Re: Lance Johnson, Lot 1R, Mulberry Hill
2007-0131-V

CASE NUMBER 2007-0131-V

Lance Johnson, the applicant, seeks a variance (2007-0131-V) to allow a dwelling addition with disturbance to steep slopes on property located along the east side of Mulberry Hill Road, east of Providence Road, Annapolis.

GO20 GRADING & SEDIMENT CONTROL PLAN

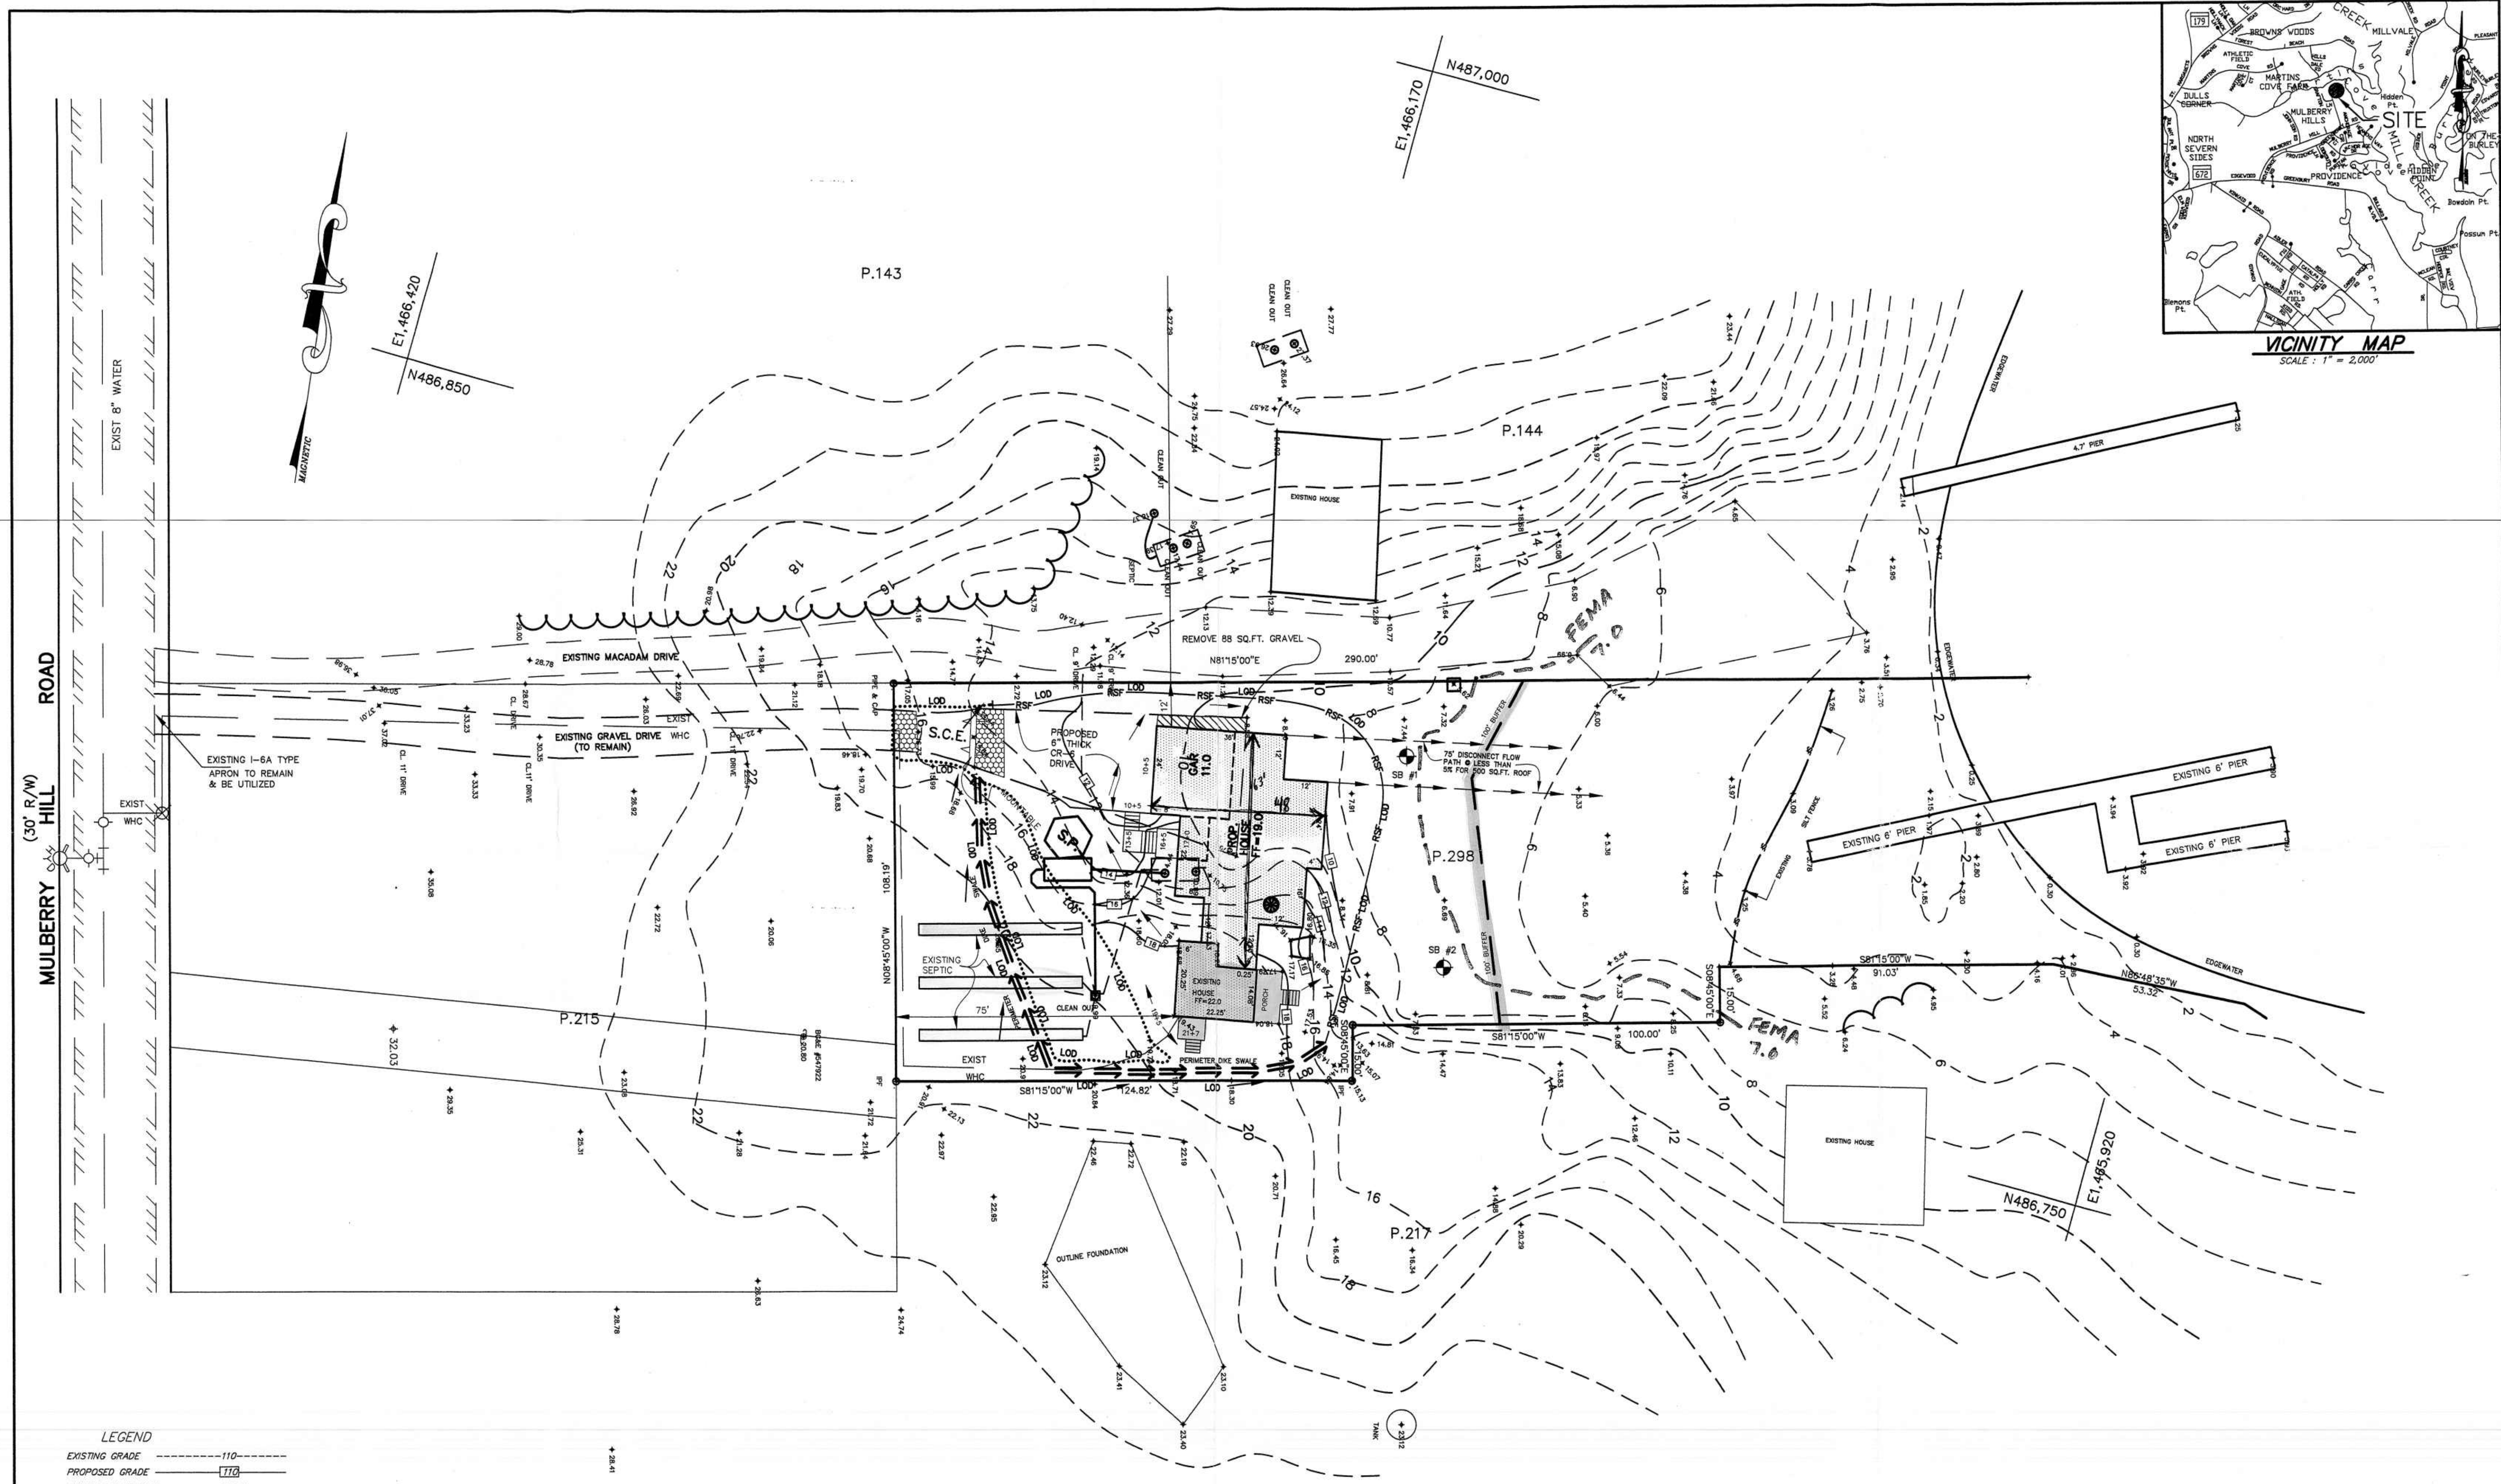
- The size of the proposed dwelling does not appear to be the minimum disturbance necessary to develop this lot. While it is our understanding these are man-made slopes, neither the County Ordinance language nor the Critical Area regulations differentiate between natural versus man-made slopes, and any impacts to slopes can create negative environmental impacts.

- The applicant has the burden to demonstrate unwarranted hardship. The lot already enjoys a single family dwelling. While we do not oppose expansions of dwellings, those expansions must show minimization. It does not appear the current plan demonstrates minimization to the steep slopes on this lot.

- We recommend the applicant find alternative and creative ways to redevelop the site with less impacts to the steep slopes. We understand the slopes bisect the lot, however, it does not appear an effort was made to minimize disturbance. For example, if the existing dwelling will remain and there needs to be a connection to it, perhaps a narrower connection could be made. Alternatively, a new dwelling could be located on the northern side of the lot to avoid the slopes.

- If a variance is granted, mitigation at a 3:1 ratio shall be provided for all new disturbance to the steep slope area. Disturbance includes grading, footprint and clearing.
- Since the site is in the LDA, and there is currently not 15% forest cover, afforestation is required. The planting plan provided shows the appropriate amount of afforestation, however, it appears the planting proposed will address both the afforestation requirement and the stormwater management planting. These two plantings cannot be combined. Therefore, the planting plan must be amended to show plantings that address the afforestation requirement and the stormwater plantings requirement. Any required mitigation plantings for impacts to steep slopes may be combined with the afforestation plantings.

In summary, this office cannot support the proposed dwelling as currently shown on the site plan; however, an alternative that shows less impacts to the slopes might be acceptable.

1. The site plan is revised to pull back the front façade of the addition to the leading edge of the stairs projecting from the porch addition to the existing dwelling.
2. The site plan is revised to reduce the limits of disturbance to 5 feet in the front yard.
3. No further expansion of the dwelling is allowed and no new accessory structures are allowed.
4. The applicant shall provide mitigation, afforestation and stormwater management as determined by the Permit Application Center.

Comments #1: Ms. Hoerger is correct that the Critical Area regulations do not specifically distinguish between natural and manmade slopes, and her concluding sentence says negative impacts "...can." occur, but we feel that they will not necessarily occur.

The extent to which impacts to an isolated section of steep slope (of either origin) may occur can be assessed to several criteria: Distance of the slope from the waterway or shoreline; the steepness slope and type of vegetation between the section of steep slope and the waterway, and the condition of the steep slope itself.

In this case, the isolated section of steep slope is well removed from the shoreline, the intervening ground has a very gentle slope and is well vegetated with grass. I would conclude that even if there were *no* sediment controls, it is unlikely that any sediment could wash across the intervening ground to reach tidal waters, but with the required super silt fence, we can conclude that there would be *no* runoff from the house construction. Moreover, the existing isolated section of steep slope -- as created by the former property owner -- is by itself not completely stable, showing areas of existing erosion and incomplete grass cover. Therefore, the house helps stabilize this slope.

Comments #2 and #3: There was careful testimony at the hearing on the reasons why the location of the house addition cannot be moved on the lot -- save for completely demolishing the existing house and building a larger house extending closer to the water. This option would not require a variance, but would not be environmental preferable, and would sacrifice an interesting older home. Considering the current tendency of waterfront reconstructions to wipe out older homes with character, the variance better keeps the overall home in better character with the neighborhood.

1. The site Area is 27, 878 square feet.
2. The area of the site that lies within the 100' buffer is 12,600 square feet or 45% of the Lot.
3. The area of steep slopes on site is 5,648 square feet with only 1,004 square feet or 18% of that area being located within the 100' buffer.

4. The area of permanent structural steep slope disturbance is 680 square feet or 2.4% of the lot.
5. The total ultimate footprint for the Lance Johnson house as proposed will be 2,705 square feet. (This compares well with the 2,788 square feet Stansbury footprint – Case 2003-0068-V behind the subject property.)

6. A “narrowing” of the connection between the existing structure and the proposed structure would only eliminate around 56 square feet of permanent structural disturbance of the steep slopes and would not eliminate any “overall” slope disturbance since the disturbance required to construct the main house footprint would still “overlap” the area of structural disturbance.
